SUBJECT: 200 John Street East and 588 Charlotte Street
Files OPA-02-2020, ZBA-11-2020 & 26T-18-20-01

TO: SORE Associates, Attention: Catherine Lyons
FROM: WSP Canada Inc.
SUBJECT: 18M-01769-00 – Randwood Estates Development Preliminary Review
DATE: May 19, 2021

Figure 4: Watermain connection to John Street

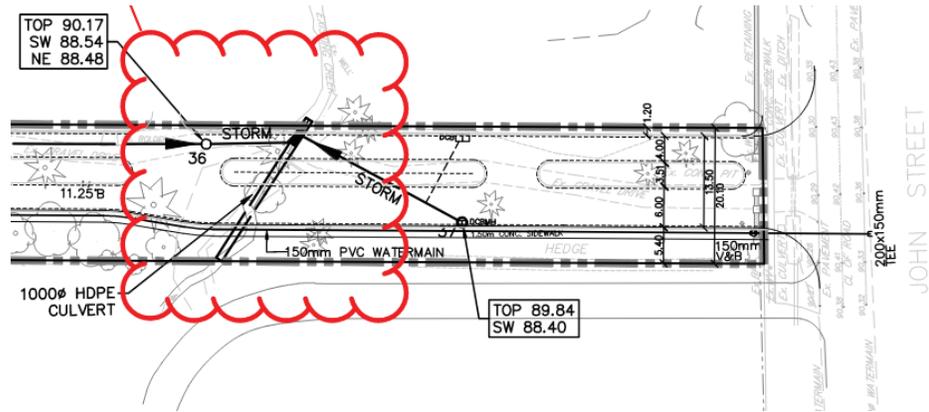
The watermain connection to John Street crosses beneath the proposed culvert. Construction of these works will impact the existing creek. Further details are required to illustrate the protection and maintenance of flow within the creek, through by-pass pumping or other measures to prevent any upstream flooding or transport of sediment that may affect adjacent properties.

Figure 5: Proposed Storm Drainage Strategy

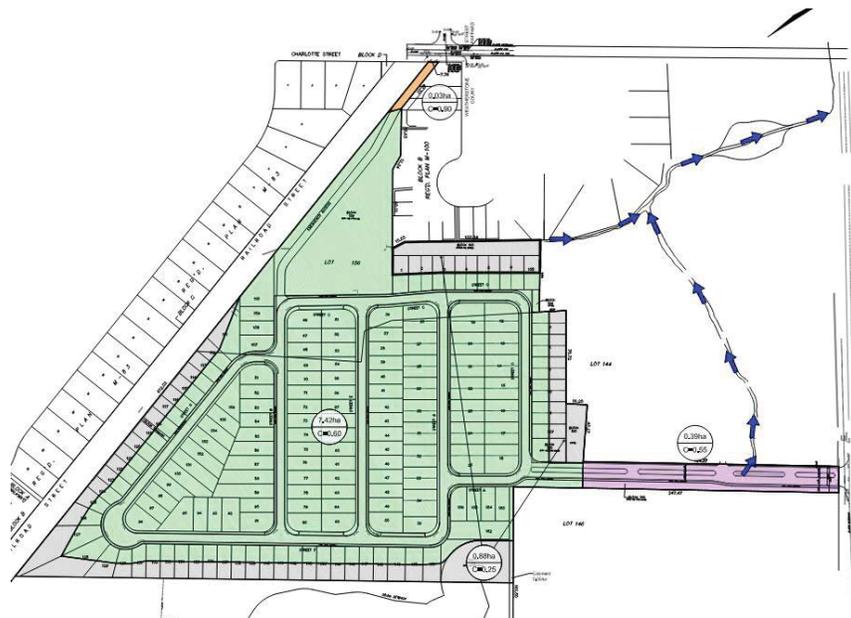
The majority of the site is proposed to be controlled through an open-bottom chamber system for both stormwater detention and quality treatment. Two areas, being the access roads to John Street and Charlotte Street will be untreated and uncontrolled. The FSR indicates the uncontrolled flow to Charlotte Street will be increased over existing conditions, however the increase is negligible. An analysis of the existing storm sewer system would be required to confirm adequate capacity in the Town's existing storm sewer system similarly to the sanitary and watermain modeling analysis. At the John Street access, the drainage area is untreated and uncontrolled. Given the 1-mile Creek floodplain appears to be constrained at this culvert in existing conditions based on NPCA Floodplain mapping, a hydraulic analysis of the creek including the proposed upgraded culvert would be required to confirm the proposed design does not cause adverse affects on the floodline. The impacts downstream by upgrading the culvert will need to be reviewed and addressed. Without quality controls on the storm outlet to 1-mile creek, hydrocarbons and sediment from vehicles can be discharged directly to the creek.

Figure 8: Grading On Adjacent Properties

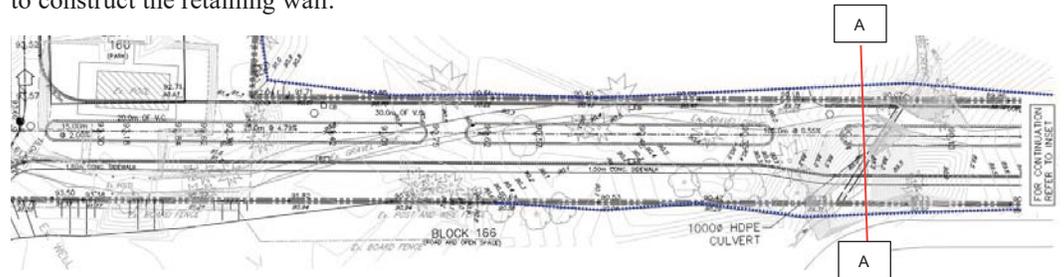
The Grading Plans provided in the Functional Servicing Report indicate grading onto adjacent properties. The property line elevations in some cases are higher than the existing grade therefore 3:1 slope down onto adjacent properties is required to tie into the existing grade. At the John Street access, the proposed culvert would need to be extended from the current design to reflect the bottom of slope. Alternatively retaining walls could be used to avoid the grading encroachment, however this is not indicated on the plans and there is inadequate space available along the west property line to construct the retaining wall.
